000 91 13.2 – ADDENDUM NO. 2

- A. Project Name: Pacific Building Conversion
- B. Owner: Kitsap County Department of Human Services
- C. Architect: Rice Fergus Miller, Inc.
- D. Architect Project Number: 2021056.01
- E. Date of Addendum: November 29, 2023

2 COMMERCIAL KITCHEN
E42.01 1/4"=1'-0"

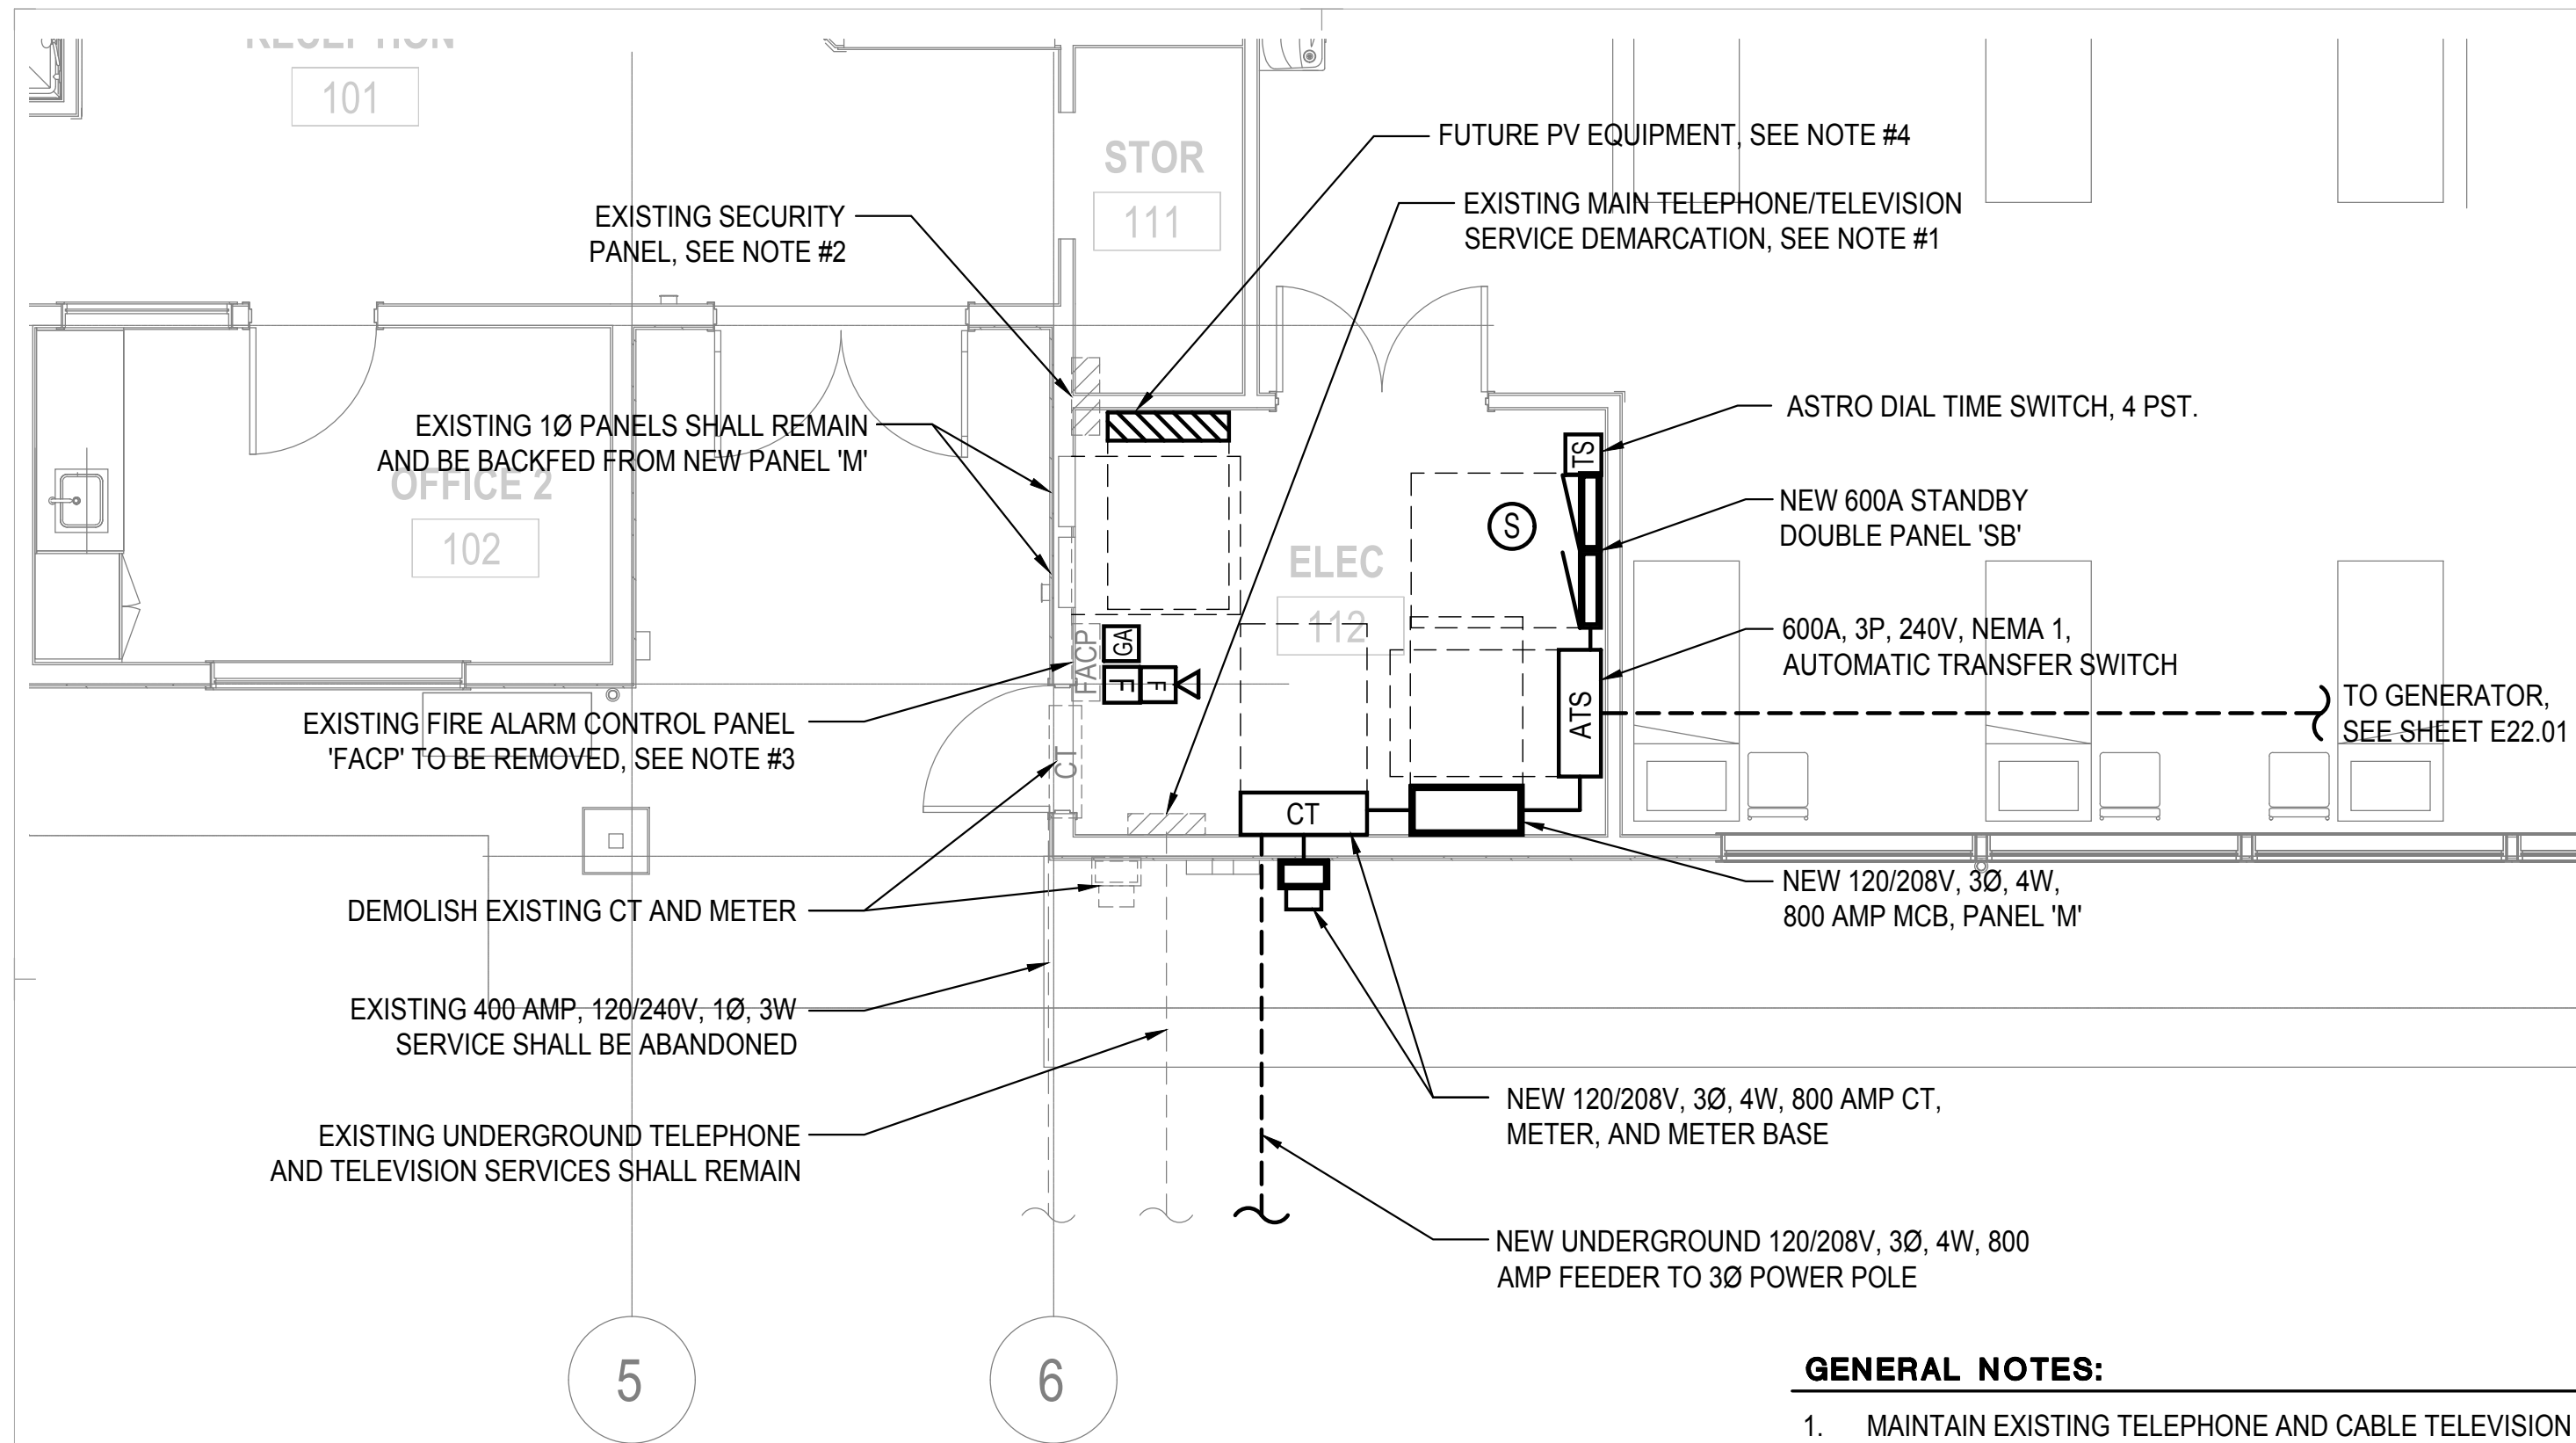
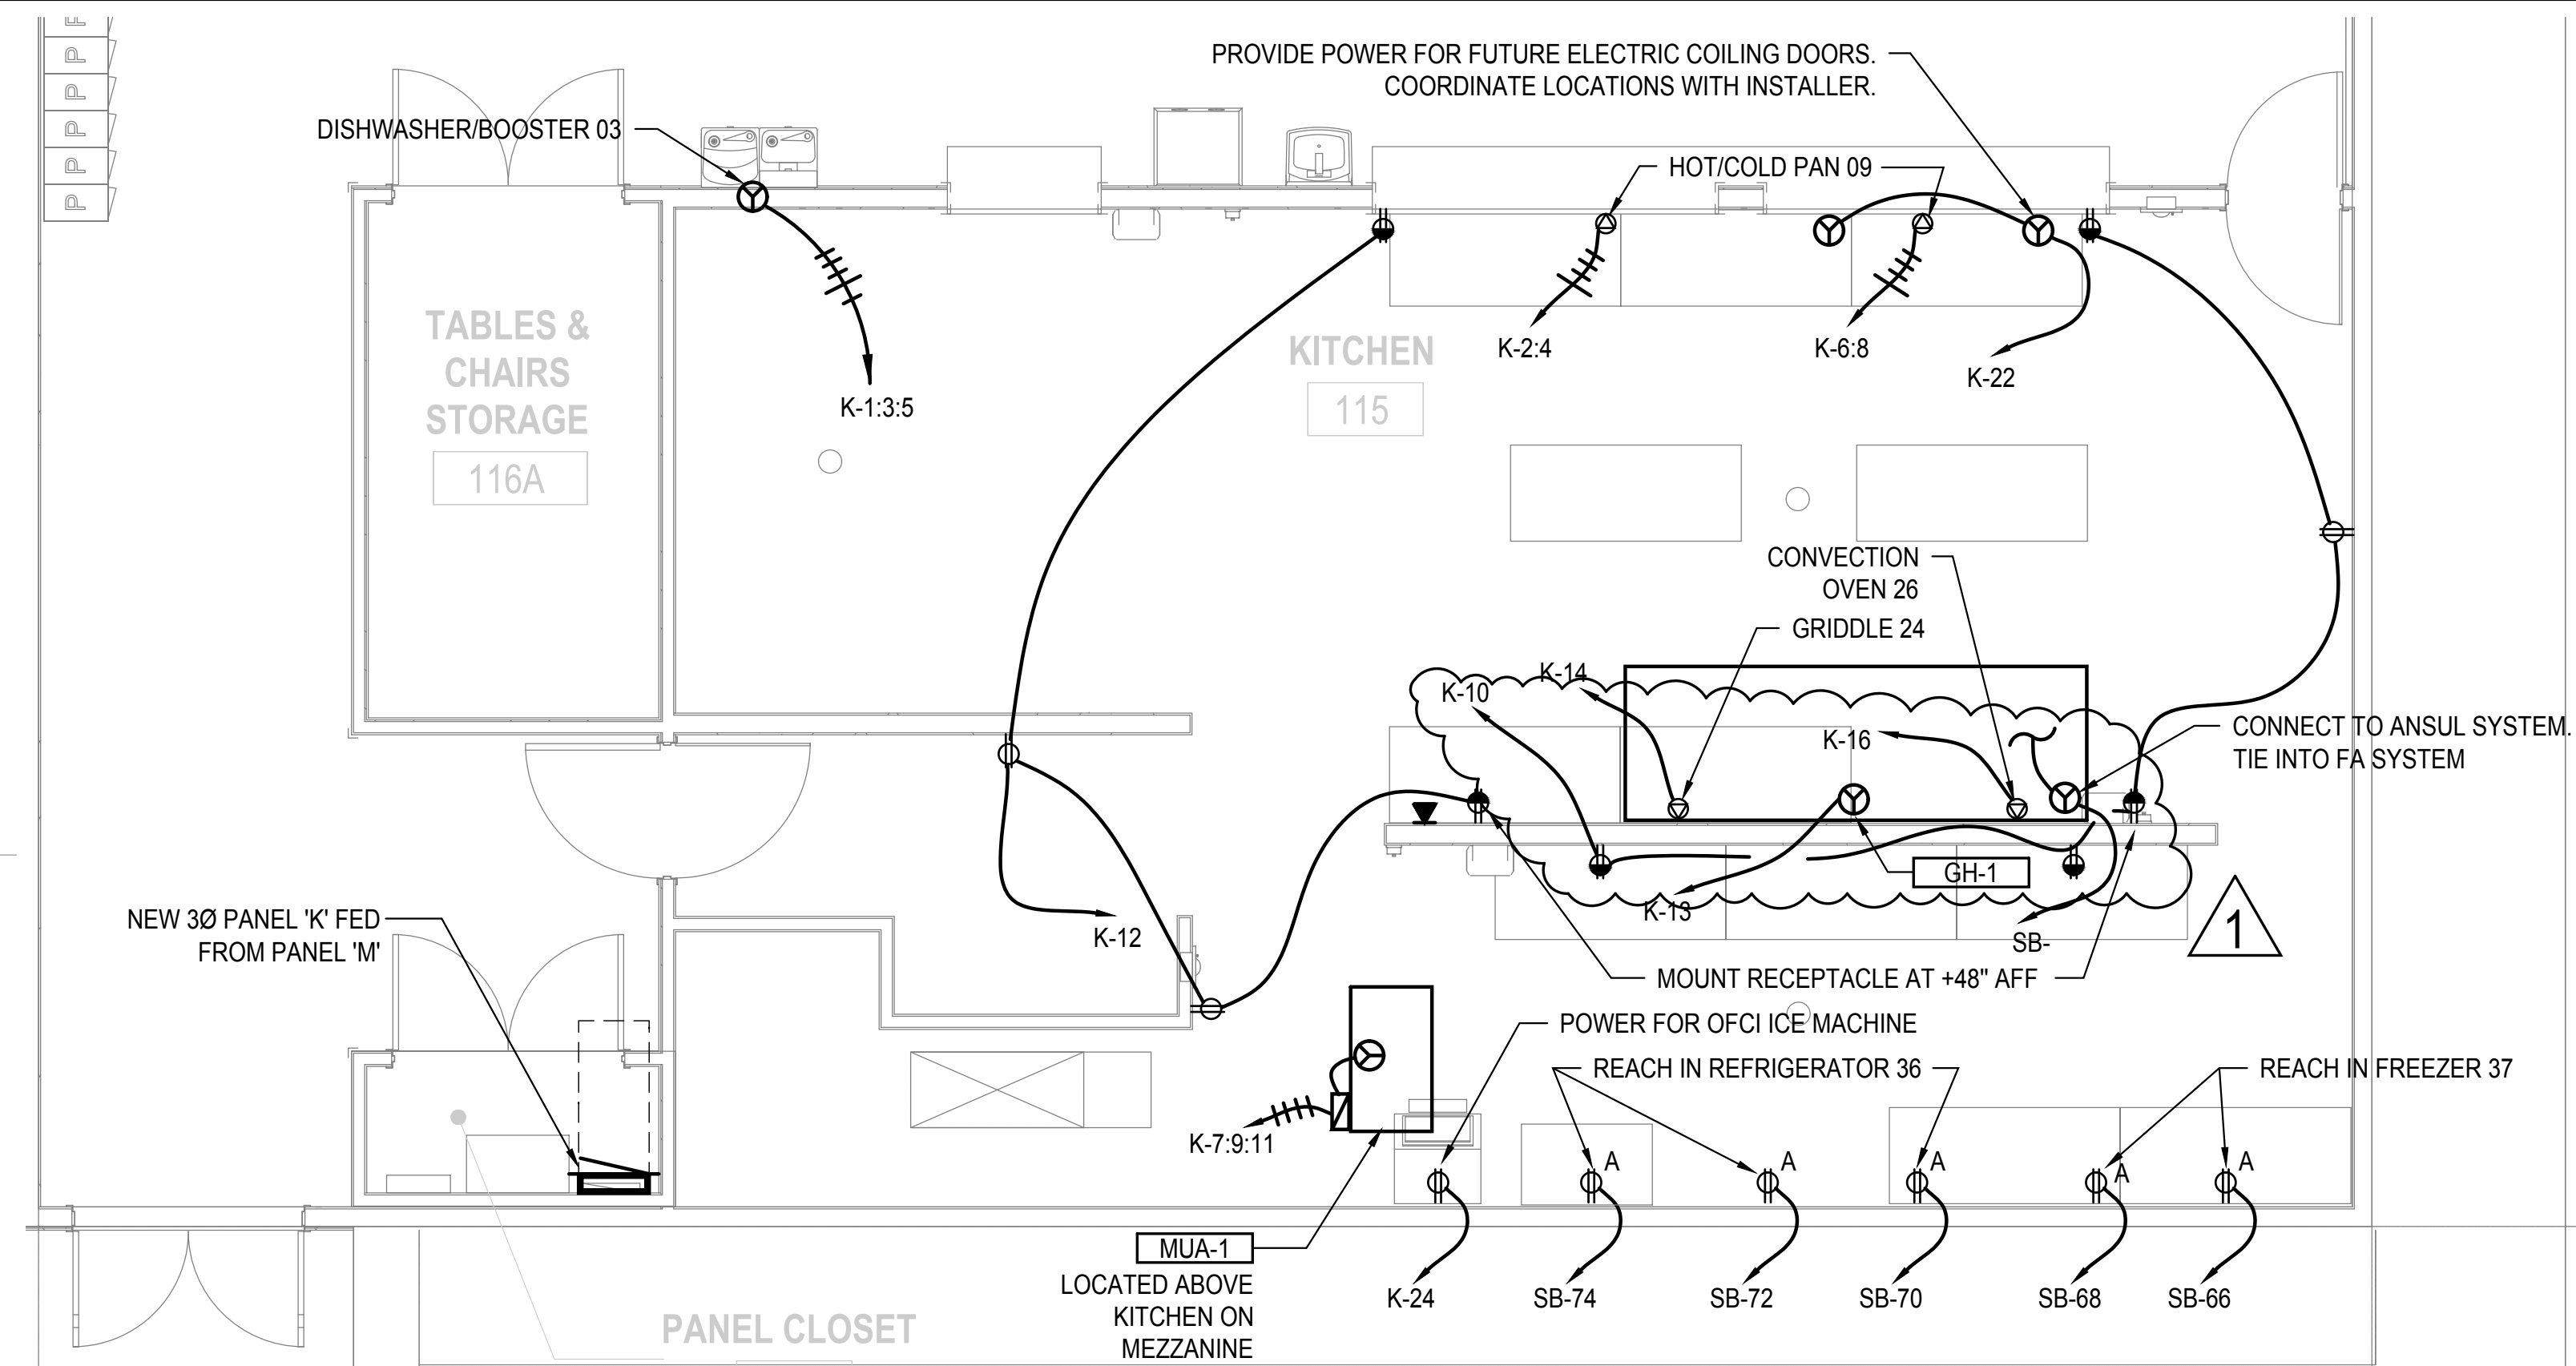
- a. Revised placement of existing Panel ‘LCA’ in Pet Care room to reflect existing conditions.
- ITEM 21. Sheet E42.01 – REPLACE in its entirety:
- a. Added duplex GFCI receptacles in wall above Item 31 worktable. Receptacles shall be mounted at +48” above finished floor.
